# **Groundwater Application Review Summary Form**

Application # G- 1877 6	
Application # G- 1877 6  GW Reviewer J. Woody	Date Review Completed: 9.24.2019
Summary of GW Availability and Injury Review	n:
	over appropriated, will not likely be available in the er rights, OR will not likely be available within the on B of the attached review form.
Summary of Potential for Substantial Interfere	ence Review:
[ ] There is the potential for substantial interfer	rence per Section C of the attached review form.
Summary of Well Construction Assessment:	
[ ] The well does not appear to meet current w review form. Route through Well Construction	ell construction standards per Section D of the attached and Compliance Section.
	ched and should be read thoroughly to understand the t may be necessary for a permit (if one is issued).
none of The above and

Application G-18776

Date: 9/24/2019

Figure 4. Stream Depletion

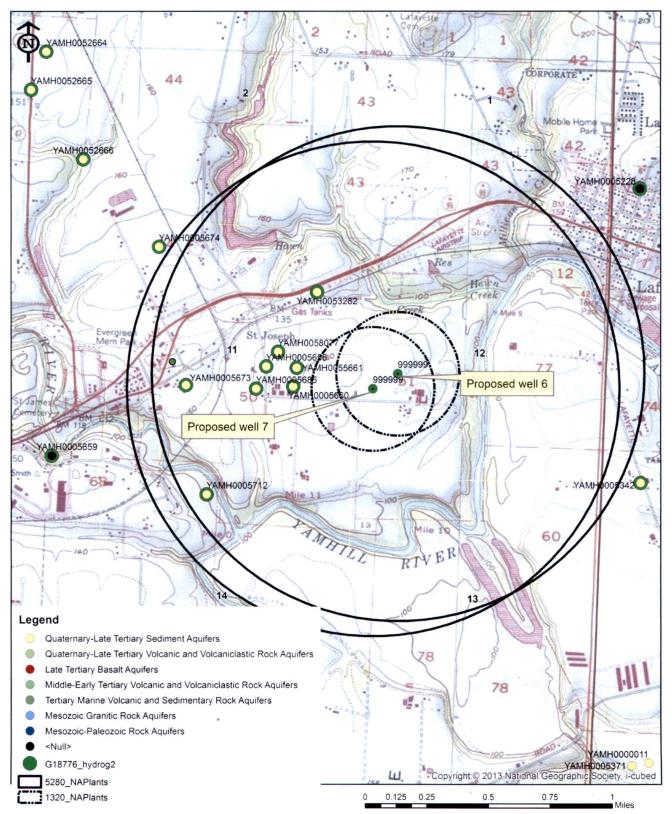
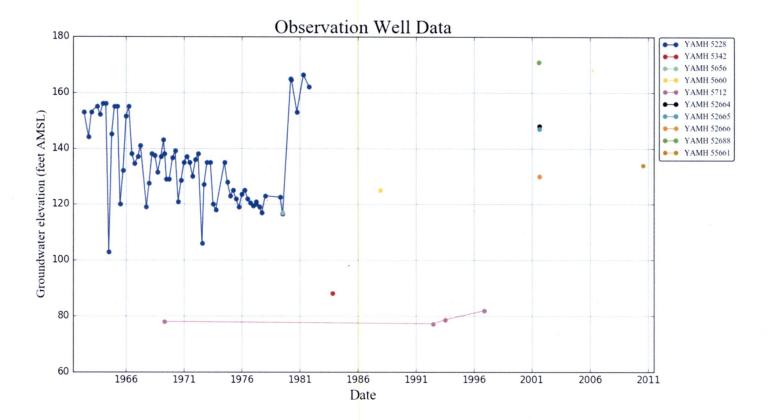
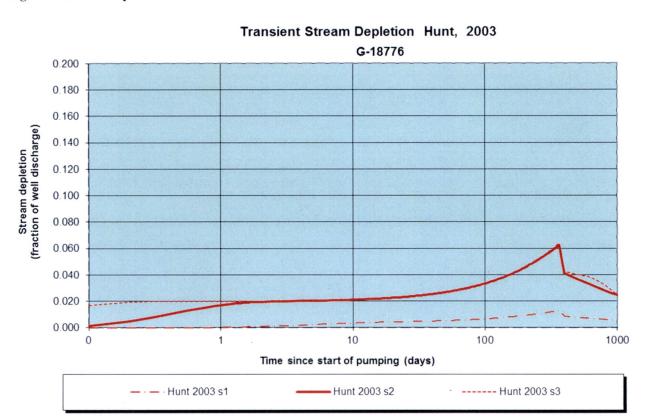
Comments:	
The rate was reduced to 0.31, so PSI is not triggered.	Stream depletion is much less than 25% at 30 days when modelled with
Hunt, 2003 (see Figure 4).
